Technical Service Information

THM 4L60-E BOLT ON BELLHOUSING

Figure 1
AUTOMATIC TRANSMISSION SERVICE GROUP

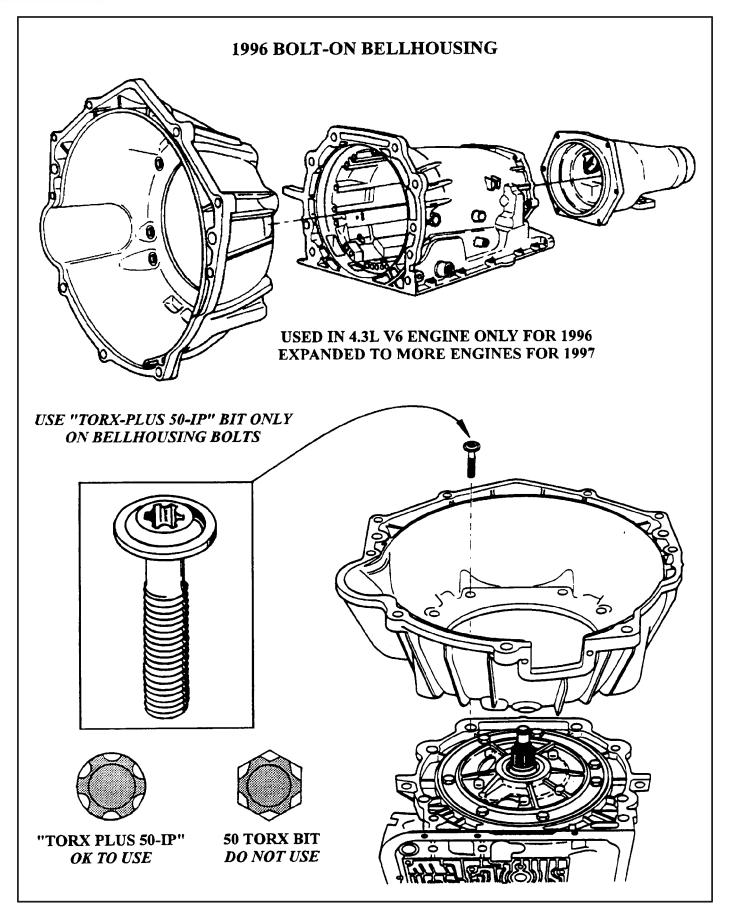
Beginning at the start of production for 1996 models, some THM 4L60-E transmissions were built with a bolt-on bell housing. The 4.3L V6 engine is the only one to recieve the bolt-on bell housing for 1996 models, and will be expanded to most other engine sizes for 1997. Refer to Figure 1 for illustrations.

- (1) BELL HOUSING Now bolted to the main case with eight bolts that require what appears to be a normal 50 Torx-bit to remove. These bolts require a "TORX PLUS SO-IP" bit to remove. The normal 50 Torx-bit will strip the head on most bellhousing bolts, if used for removal. Refer to Figure 1 for the profile of both bits.
- (2) MAIN CASE Totally different casting to accommodate the bolt-on bellhousing, as shown in Figure 1. There were no changes in worm track configuration, or bolt hole locations for the bottom pan and valve body area.
- (3) EXTENSION HOUSING Totally different casting to accommodate the changes in the case

design, and notice the new design has six retaining bolts instead of the previous four, as shown in Figure 1.

Figure 2
AUTOMATIC TRANSMISSION SERVICE GROUP

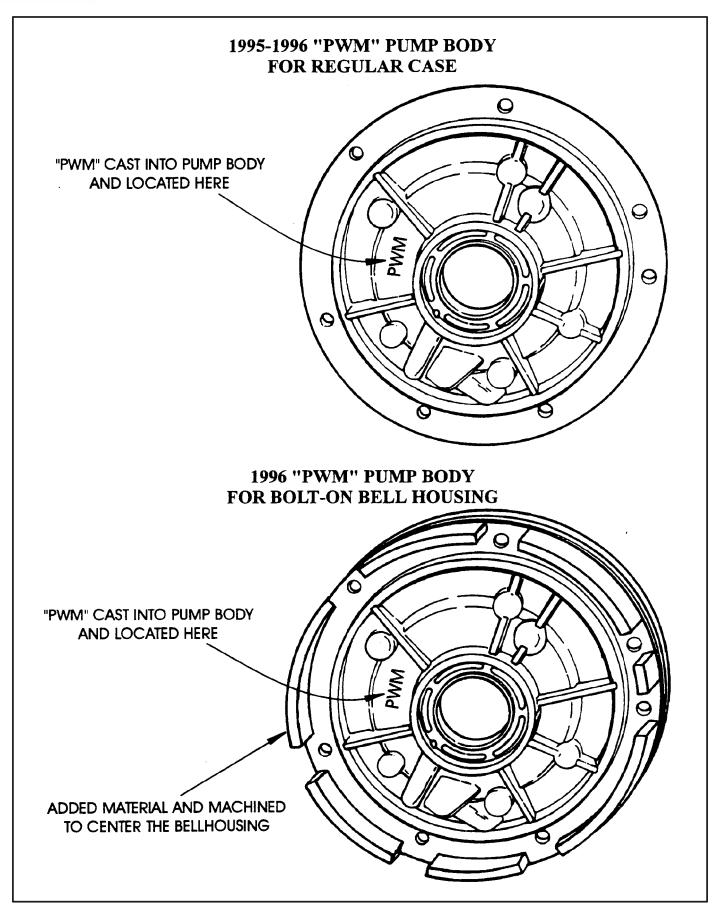
(4) OIL PUMP BODY - A machined ring has been added to the front of the pump body to accommodate and center the bolt-on bellhousing, as shown in Figure 2.
